# SES SOLAR ONE

## Supplemental Information In Response to CEC Data Adequacy Requests Application for Certification (08-AFC-13)

April 2009

**SES Solar One**  
**Supplemental Information**  
**In Response to CEC Data Adequacy Requests**  
**08-AFC-13**

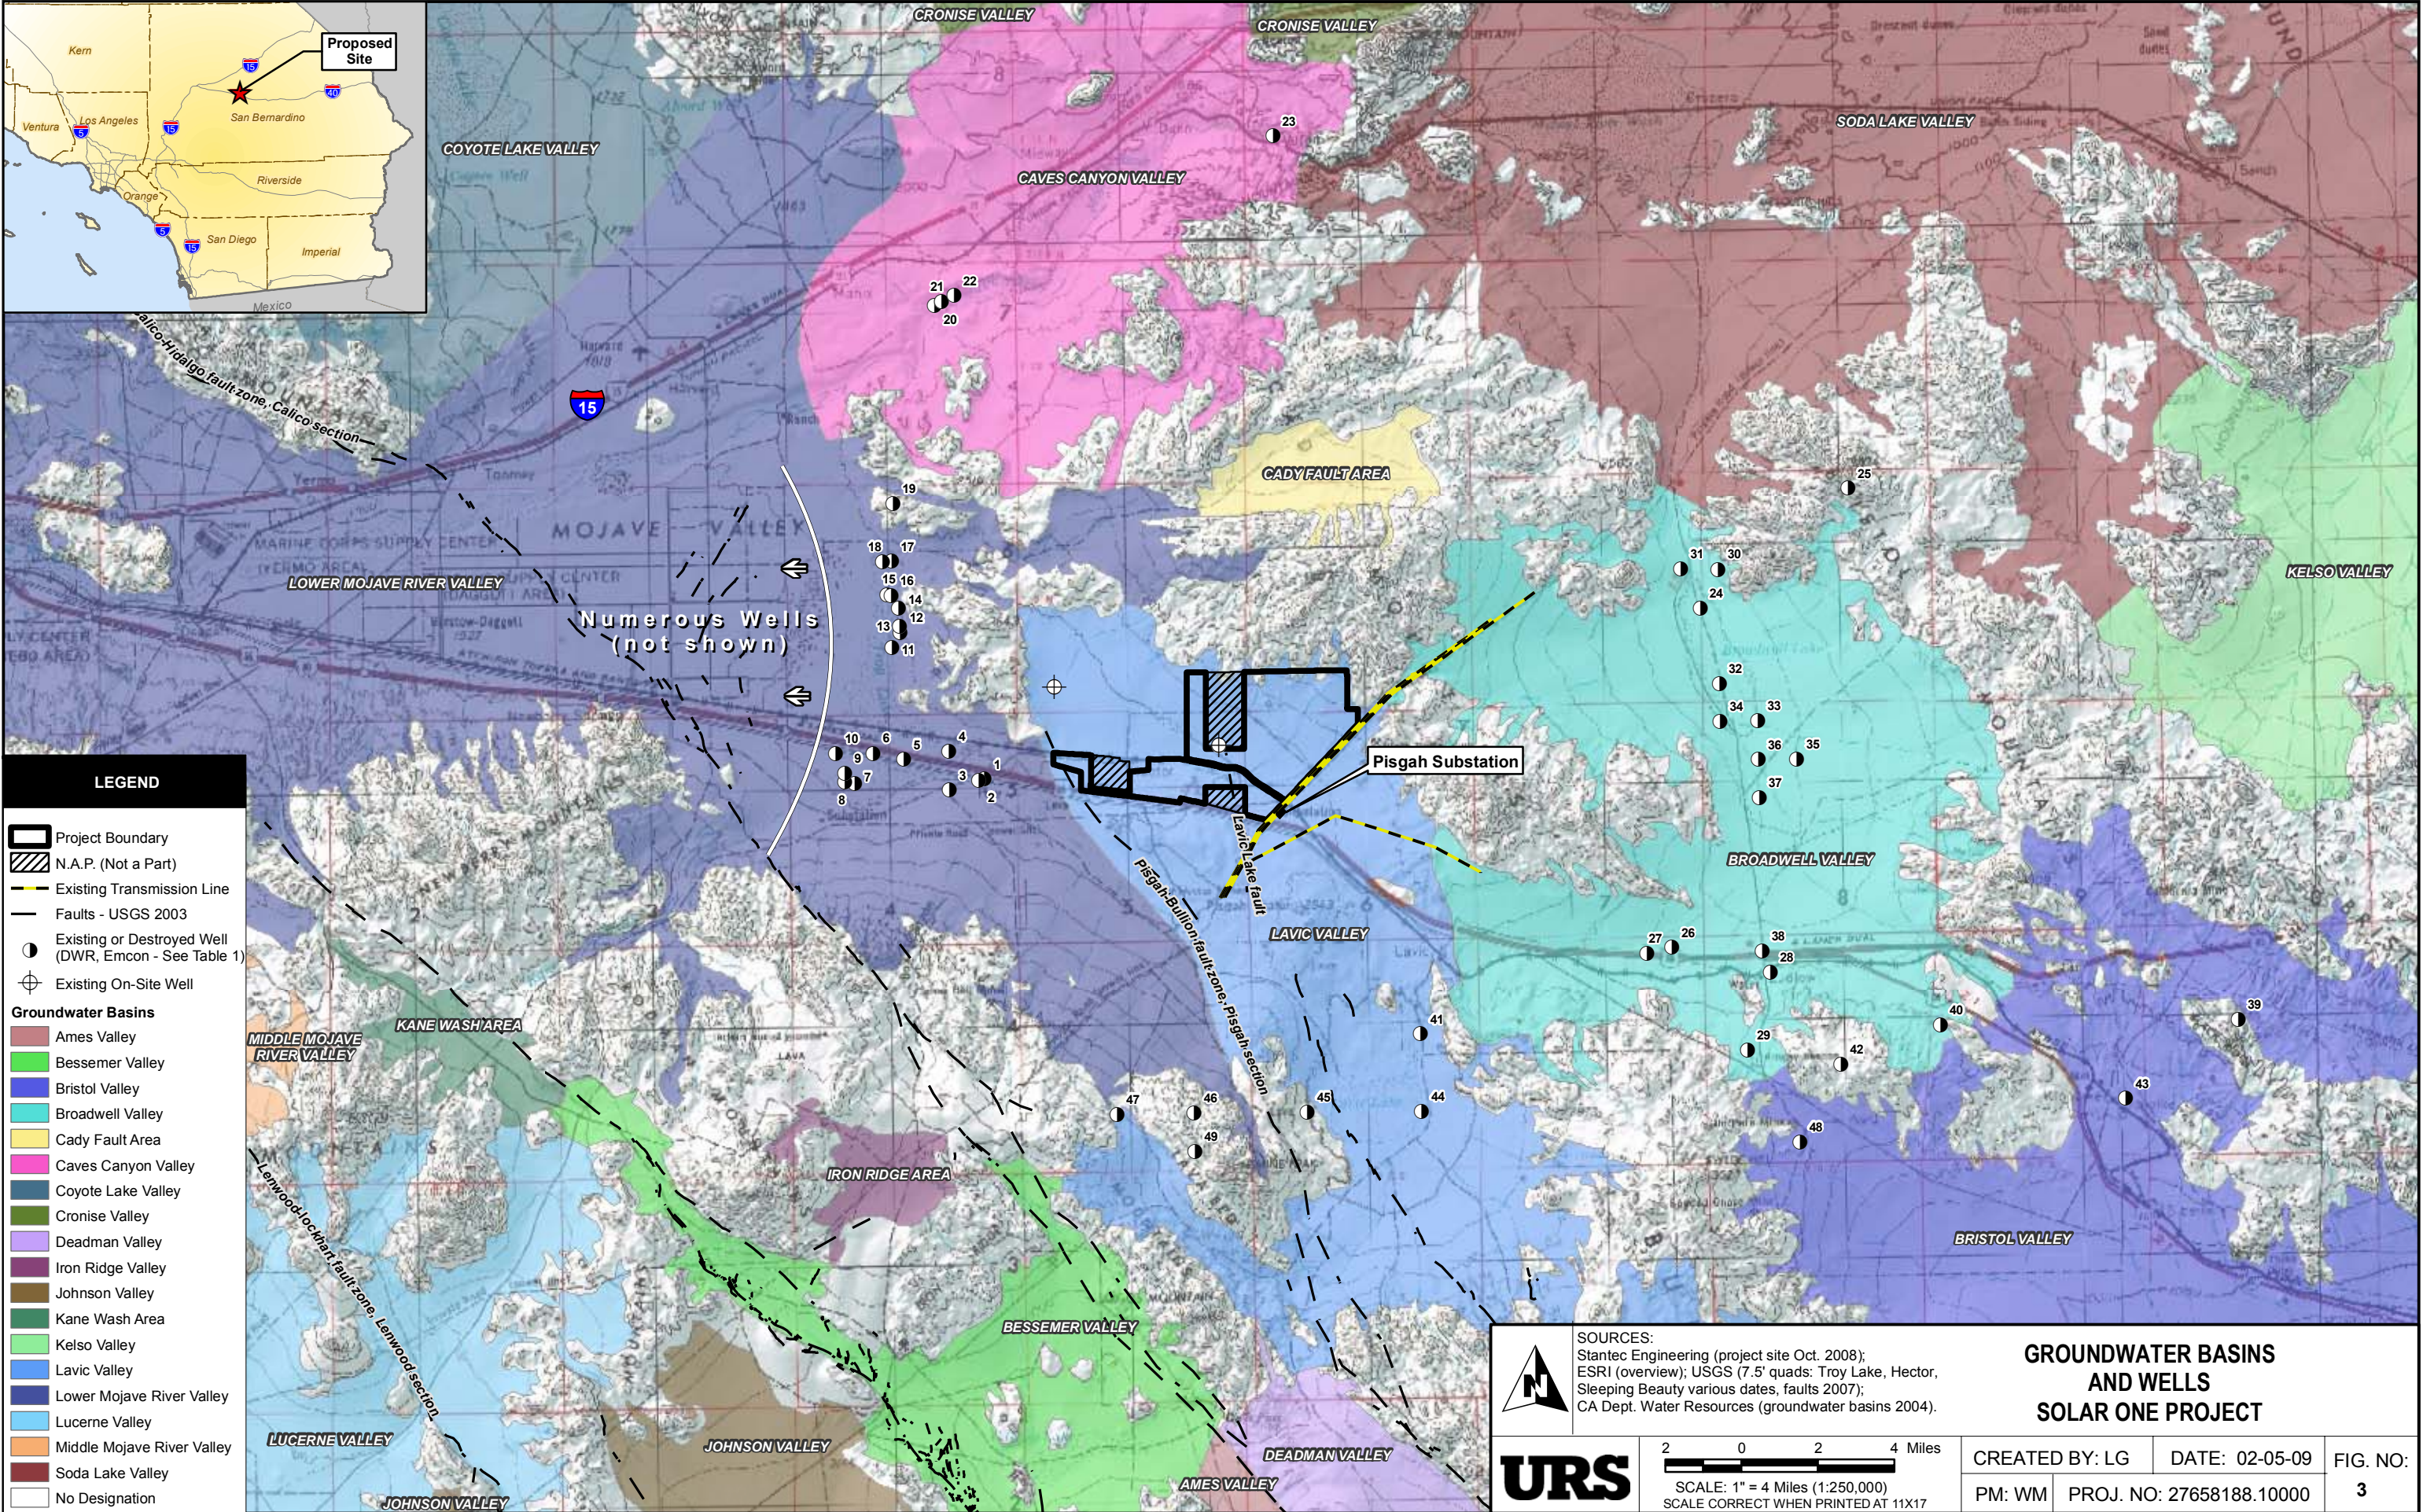
**Data Adequacy Request 49.** Please provide a discussion of groundwater wells within ½ mile of the project.

**Response:** Two groundwater wells are present within the immediate site vicinity that are not being used presently. The wells are generally in poor condition and not suitable for water use production for the project. The locations of other nearby wells and groundwater depths were researched using the DWR website and other sources available: <http://wdl.water.ca.gov/gw/map/scal.cfm>. No other wells were found within approximately one mile of the site boundaries; however, numerous wells were found in the general area. An additional search of the U.S. Geological Survey (USGS) National Water Information System (NWIS) Web Interface resulted in no groundwater well information for an approximately 400-square mile area generally centered on the site.

The existing and destroyed wells identified during the data search are shown on Figure 3, provided as attachment WR-1. Additional details, including well location, ground surface elevation, and well and groundwater depth (where available) are presented in Table 1, provided as attachment WR-2 to this response.

Within the Lavic Valley groundwater basin, records for several wells constructed in the late 1800s and early 1900s were located in the central/southern part of the basin (close to Lavic Lake, see wells 41, 44 and 45 on Figure 3) approximately 7 to 9 miles from the site. The data indicates that groundwater depths measured in the 1960s and earlier ranged from 53 to 64 feet below the ground surface. A pumping rate of 140 gallons per minute (gpm) was recorded in well no. 44 in 1917 (DWR, 1967). More recent data for these wells has not been reported. Based on the review of existing data, no wells were identified in the basin that were closer in proximity to the site.
